**RE: DENDROBIUM MINE – PLAN FOR THE FUTURE: COAL FOR STEELMAKING (SSD 8194)
– HERITAGE COUNCIL NSW RESPONSE TO SUBMISSIONS REPORT**

ATTACHMENT 1
RESPONSE TO HERITAGE COUNCIL NSW COMMENTS

Figure 1

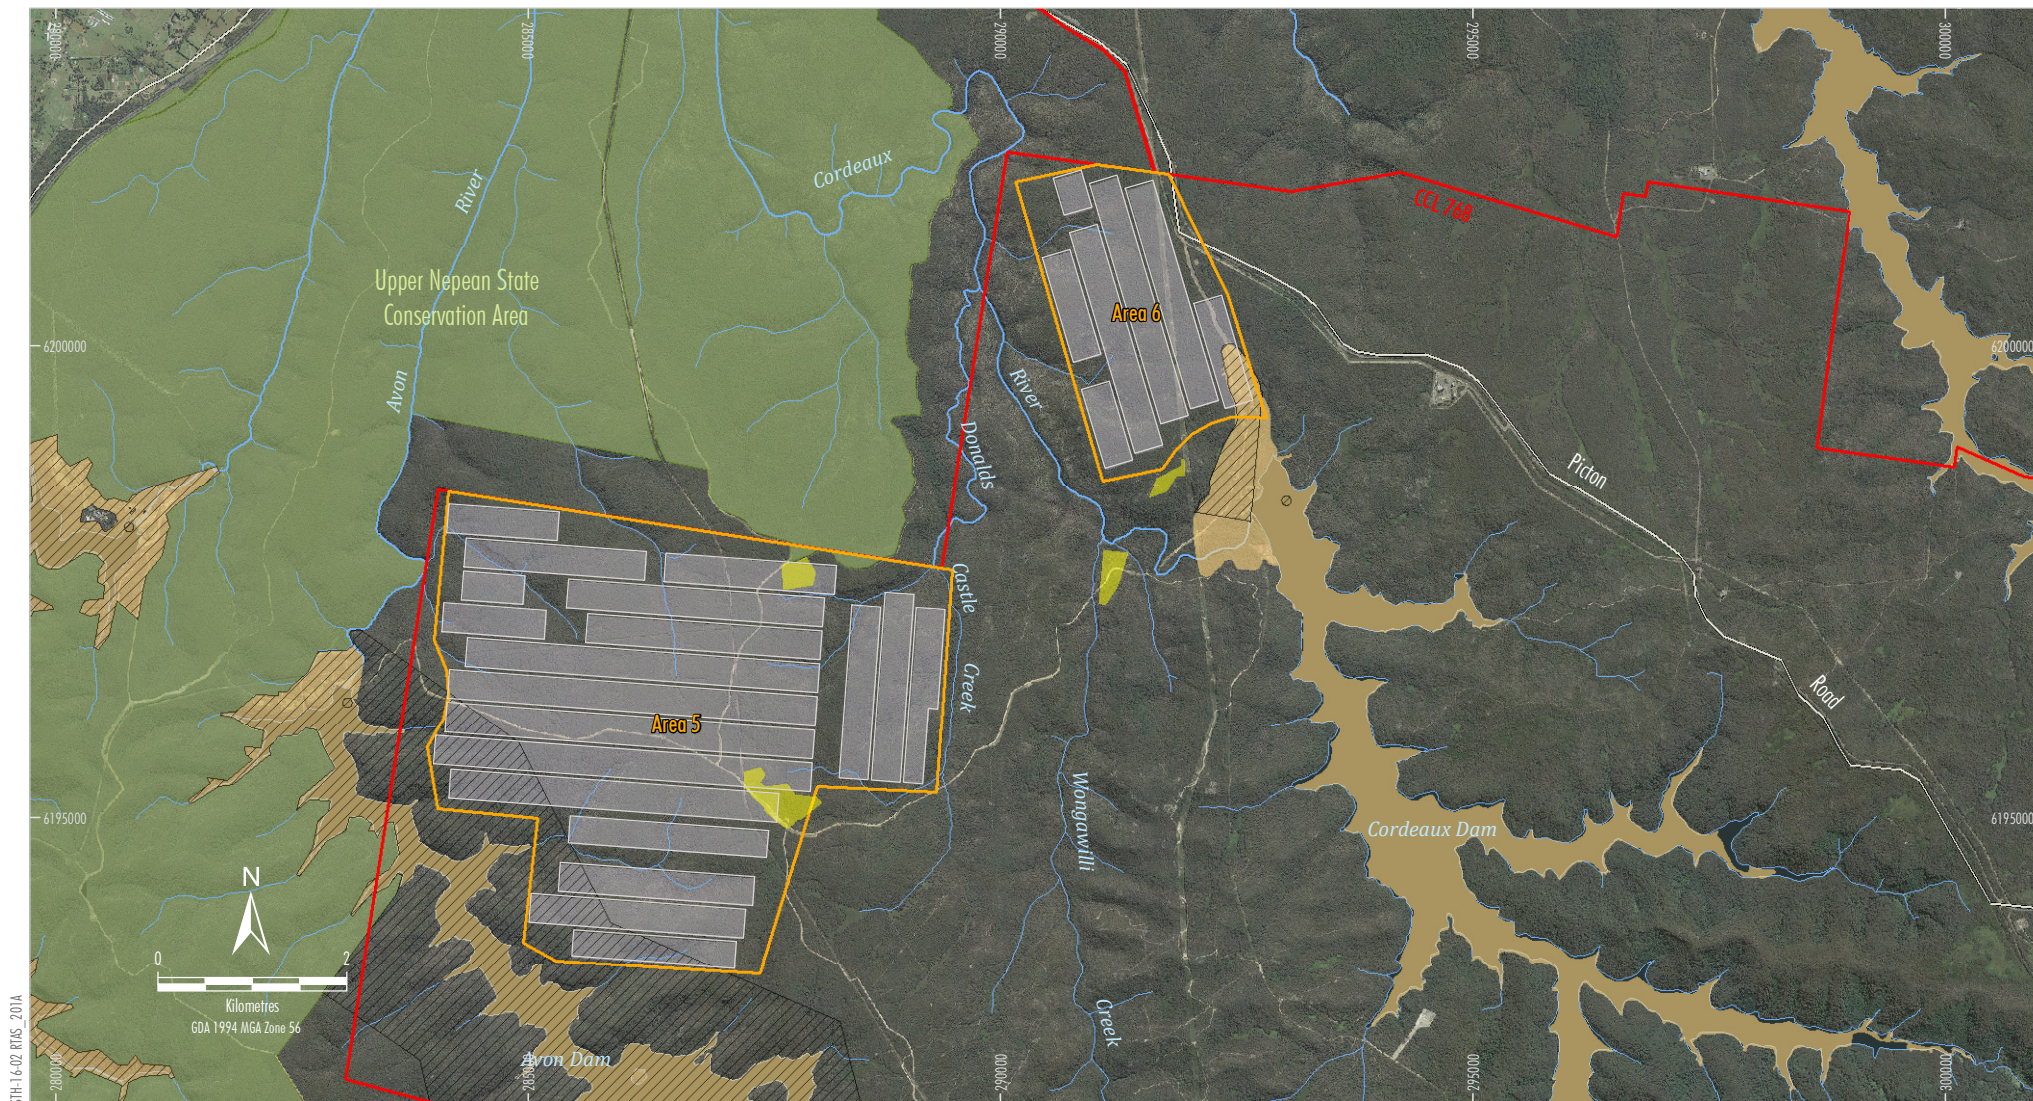
The Heritage Council recommended the relocation of the project areas outside of the SHR curtilages of Avon and Cordeaux Dams, however it is noted that this recommendation has not been addressed...

The Heritage Council reiterates its assessment that subsidence could potentially radically alter the built and landscape elements within these SHR curtilages, resulting in unknown, irreversible and unacceptable impacts from ground subsidence and surface fracturing upon the SHR items.

The Heritage Council requested that Figure 5 of the HHA was amended to correctly show the SHR curtilage of the Cordeaux Dam. This has not been provided in the RTS report.

Figure 1 shows the effect of these setbacks in avoiding the majority of the SHR curtilage area. The Project layout avoids all but a small portion of the SHR curtilage associated with the Cordeaux Dam. That small portion lies well north of the main recreational area and dam structures of higher heritage significance.

Subsidence impacts would occur within small portions of the SHR curtilage areas (Figure 1). These areas are largely native bushland. Based on observations from decades of longwall mining in the Metropolitan Special Areas, no significant alterations to vegetation are expected. In addition, the undulating and incised nature of the landscape includes slopes which are significantly greater than any subsidence induced tilt and will therefore not be observable from the SHR areas. Therefore, it is not anticipated potential subsidence impacts would significantly alter the landscape values of these areas.

Please refer to Figure 1.

The location of the proposed ventilation shaft sites in relation to the Avon Dam and Cordeaux Dam curtilage areas and dam walls is shown in Figure 6-18 of the Project EIS and is described in Section 6.20.3 of the Submissions Report. They are also shown on Figure 1.

FIGURE 7

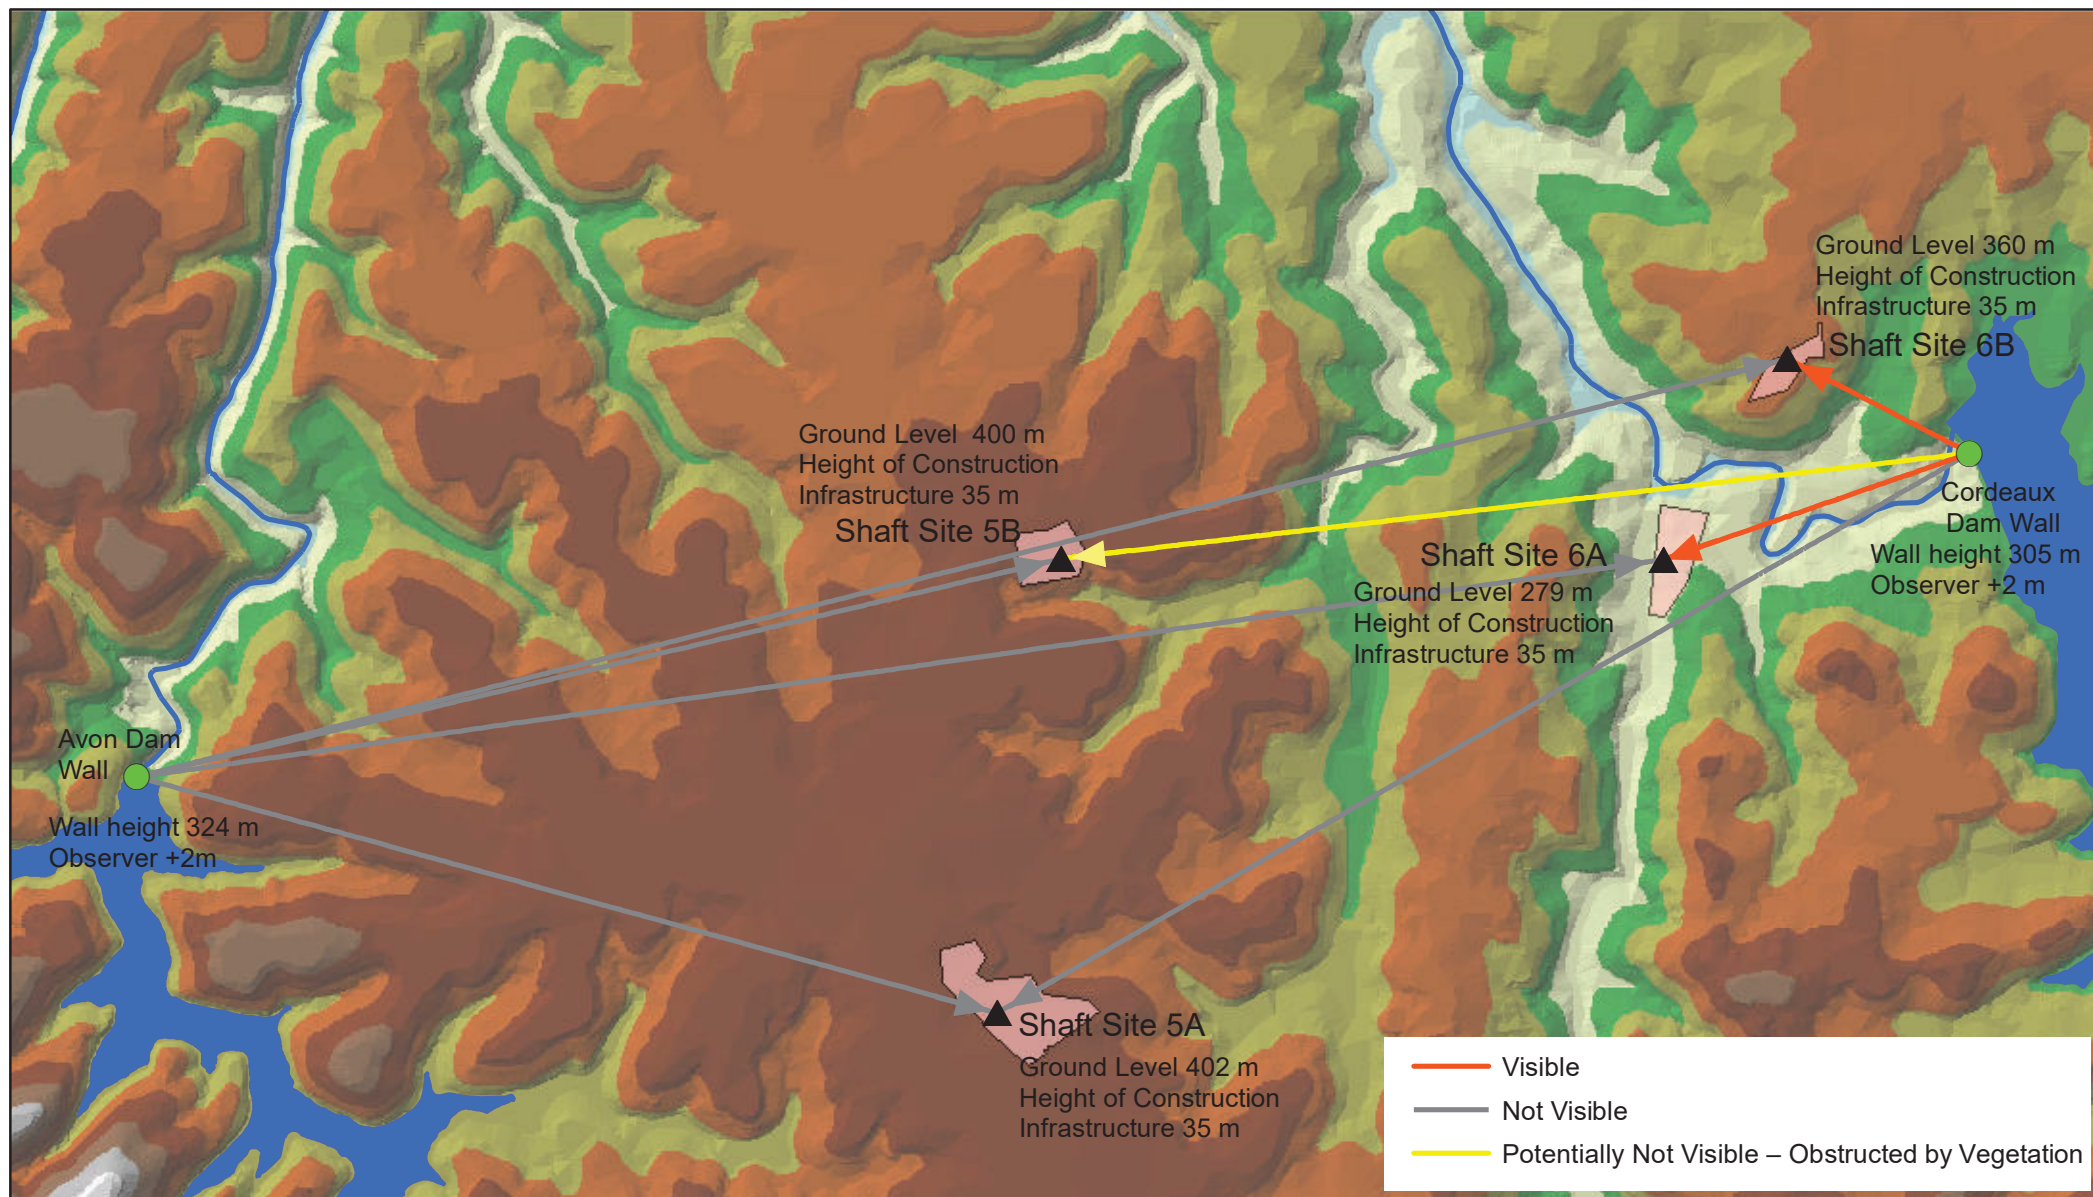
The RTS report does not provide clarification as to the location of the proposed ventilation shafts in relation to the SHR items or to the visual representation of these shafts ... Even though the report subsequently states that these shafts would not result in adverse impacts on the visual amenity or heritage values of the Avon and Cordeaux dam walls, insufficient information has been provided to the Heritage Council to assess these impacts. No further clarification has been provided in relation to the impact of the ventilation shafts upon view points, other than from the dam walls.

As noted by the Heritage Council NSW, visual assessment from the dam walls has been conducted for the Project. The basis for the assessment of potential visual impacts by Niche (2019) is illustrated in Figures 7, 8 and 9 of Appendix G of the EIS (reproduced below).

The dam walls were selected as the viewpoints as they are the publicly accessible recreational areas within the SHR curtilage.

Other viewpoints have not been considered on the basis that, with the exception of access tracks surrounded by dense vegetation, there are no other publicly accessible viewpoints of the proposed ventilation shafts from within the SHR curtilage.
